28 May 2025
Ref: 252145.2L

Submission on behalf of the Owners' Corporations of 'Metro Residences' – 'Metro View' (SP 88677) at 69 Albert St, 'Metro Spire' (SP 88678) at 1 Post Office Lane and 'Metro Grand' (SP 88679) at 438 Victoria Avenue, Chatswood – SSD-63324208 410-416 Victoria Avenue, Chatswood – Construction of a build to rent (BTR) development with ground and first floor retail premises, 260 BTR units, communal facilities and 3 levels of basement

Figure 2: Extracts from SSD Shadow Diagrams
(Source: SSD plans; annotated by DC)

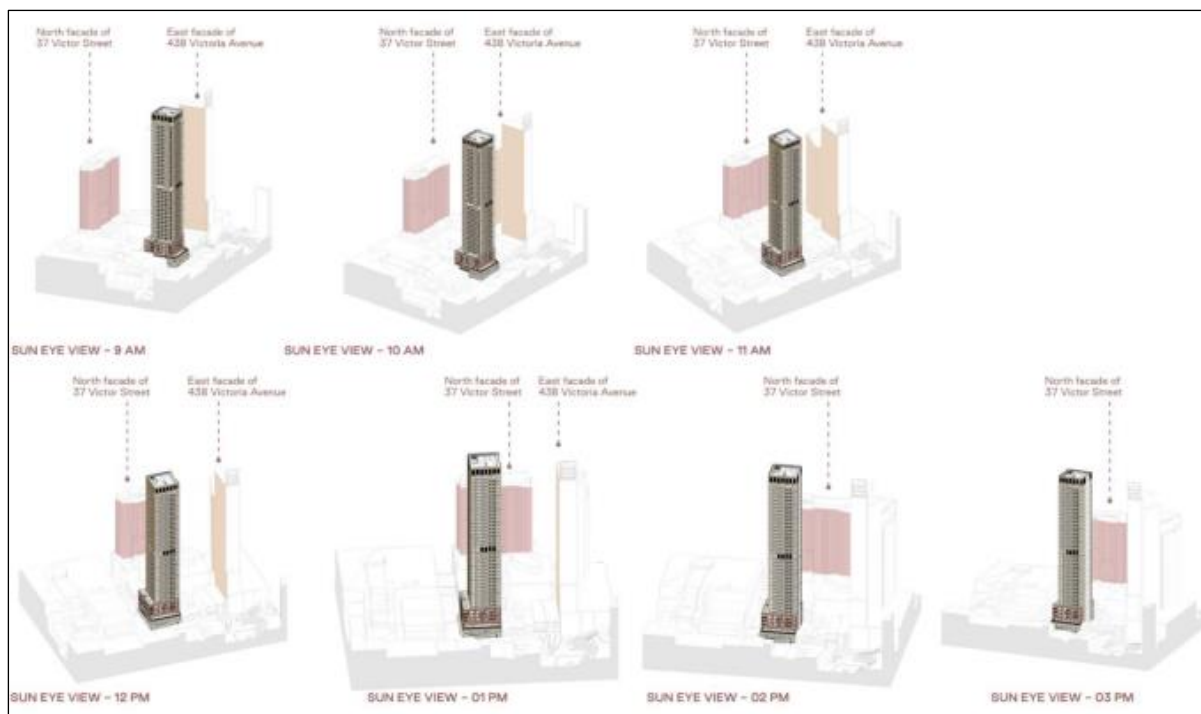
The proposal will result in additional overshadowing of Metro Spire and Metro View as shown in the midwinter shadow diagrams and 'Sun Eye View' diagrams from the EIS (p. 93)/architectural plans (see **Figures 2** and **3**).

The proposed SSD will have a significant adverse impact on the level of solar access achieved to the south-east-facing units in Metro View. The level of impact is such that these units will not achieve 2 hours solar access in accordance with the criteria under the ADG.

As shown above, at 9am and 10am, the proposal will overshadow most of the eastern façade of Metro View. At 9am, solar access is retained only to the SE corner of the building. At 10am, solar access is retained to the northern elevation/NE corner. This level of impact represents a significant and marked reduction in solar access to these units compared with the existing situation.

At 11am, the diagrams show there is no direct impact on Metro View and solar access is achieved to the eastern façade.

However, at 12 noon, due to the angle of the façade, the diagrams show that solar access would not be achieved to the south-east-facing units in Metro View.

Accordingly, the proposal will reduce the solar access of south-east-facing units in View such that they would not achieve the required 2 hours at mid-winter to living rooms/private open space. The 'as built' plans of Metro View indicate that there are units with living rooms and private open space at Levels 5-31 which would be adversely affected by this loss (see **Figure 4**). This will result in a significant loss of amenity to these units which currently achieve 2+ hours solar access throughout the morning.

As shown in the diagrams above, at 9am, the proposal will overshadow the SE corner of Metro Spire. By 10am, Metro Spire is not overshadowed. This overshadowing would affect the SE corner living rooms/wintergardens of units at each level of the building but is considered minor.

It is submitted that the proposed development should be amended through provision of greater setbacks to the proposed tower to reduce its bulk so that the south-east-facing units in View achieve the minimum 2 hours solar access to living rooms/private open space. In addition, the assessment of compliance and impact should be revised and based on the actual unit layout within each of the buildings rather than on the basis of 'facades'. Without such an assessment the conclusions reached in the submitted SSD documentation cannot be relied upon.

Figure 5: EIS View Impact Diagram

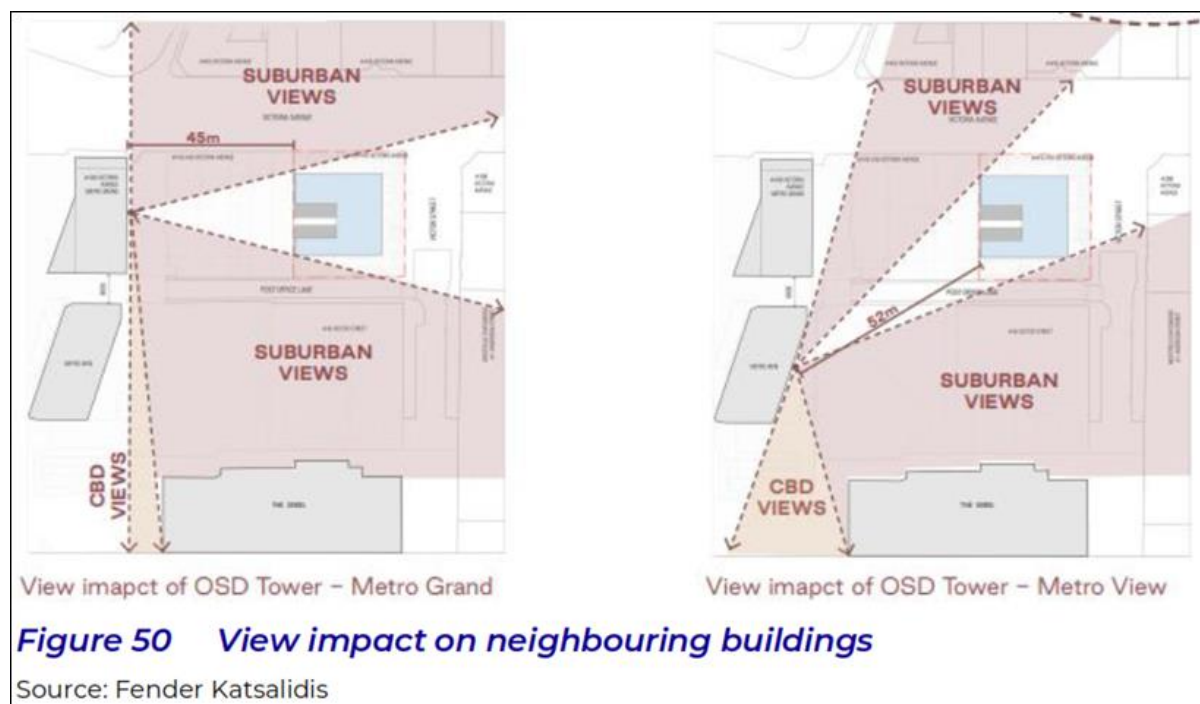
The proposal will result in a loss of views from both Metro Spire and Metro View. The EIS contains diagrams showing "View Impact" (noting the heading "Metro Grand" below should be "Metro Spire") (see **Figure 5**).

The EIS acknowledges that the Metro Spire and Metro View have “expansive suburban” views which will be impacted by the proposed SSD, however, concludes that the impact is “acceptable” on the basis of the portion of view affected and the dense CBD context (p. 98). The EIS also indicates that the views affected are not ‘iconic’ or ‘highly valuable’ in the context of *Tenacity*.

The assessment of views in the SSD documentation is refuted on a similar basis to that undertaken in relation to overshadowing and loss of solar access noted above, in that the assessment is highly generalised and makes no attempt to assess the impact on particular units, taking into account varying layouts and outlooks. This is illustrated by the diagrams in **Figure 5** above, which depict the view from a single point in the centre of each building façade.

In particular, it is noted that very few units have the full width of view described/illustrated in the EIS and SSD documentation. Arguably only the units at the two top floors of Metro Spire have that view as they occupy the whole level. At the lower levels of Metro Spire and Metro View, the easterly/north-easterly views vary according to unit layout. In this regard, the units most affected by the proposal will be the single aspect easterly facing units in Metro Spire at the lower levels – Levels 11-20 – which directly face the SSD site.

Apart from the units at the lowest levels of Metro Spire (Levels 5-10) which have opaque glass to the eastern façade, all east-facing units in Metro Spire will be affected by a loss of views/outlook to the east resulting in a loss of amenity to numerous dwellings. From Metro View, the units in the north-eastern part of the building at all levels will be most affected.

In addition, the view impact assessment in the EIS underplays or discounts the value of the existing views to the amenity of the units within Metro Spire and Metro View. This value is partially derived from their expansive, uninterrupted nature, albeit that they are over a suburban context without ‘iconic elements’. As a result, the assessment underplays the impact of the proposed SSD on the existing views and the amenity of the units in our clients’ buildings. Based on the diagrams above, the impact of the proposed development would be to remove the central portion of the existing wide view, which is considered to be a significant impact as it would fundamentally change the nature of the existing view from the affected units and reduce their amenity.

It is submitted that more detailed assessment of this issue is required which properly takes into account the unit layout of our clients' buildings rather than the generalised approach taken in the EIS and SSD documentation. This will enable a proper assessment of the view impact of the proposed SSD.
